Application Number: SD-V-04-21

Block 801 Lots 5, 6, and 7 409-413 Lippincott Avenue

Minor Subdivision Approval

Planning Letter #1

Figure 1 – Site and dwelling illustrated on Sheet 5 of the 1911 Sanborn Map, courtesy Princeton University Library.

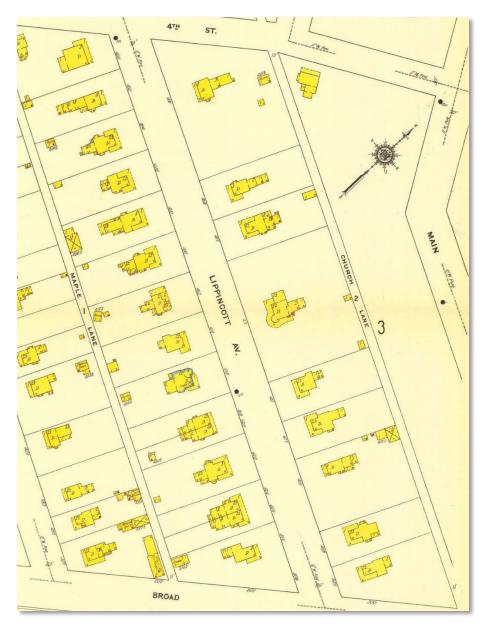
- h. Streetscape preservation should be addressed and specifically, the requirement that no new lot be created, or subdivision approval granted within any residential district unless the lots created are equal in size, shape, and orientation, as defined, to the prevailing character of the street. The orientation is related to the relationship of existing buildings along the front, side, and rear lot lines. Further, the standard is intended to advance the design, layout, and aesthetic values associated with existing patterns of development.

A portion of Sheet 5, 1911 Sanborn Map illustrating the predominant orientation of the existing dwellings on the street is provided, following page.
